Subject: TRUNK REQUEST SWITCH INOPERATIVE	Bulletin No: 09-013/07
	Last Issued: 4/3/2007

2006-2007 RX-8 vehicles equipped with Advanced Keyless System with VINs below JM1 FE**** ** 212388 (built before February 1, 2007)

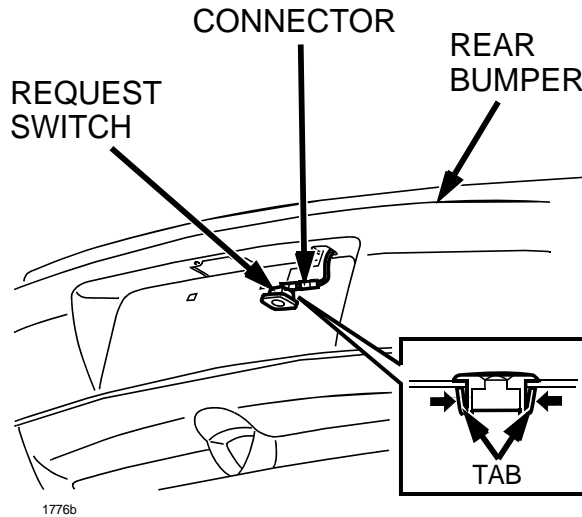
Water may enter the switch, damaging the terminals and cause a malfunction. The switch design has been changed to prevent water damage. Customers having this concern should have their vehicle repaired using the following repair procedure.

c. Detach request switch from the rear bumper by squeezing the tabs inward.
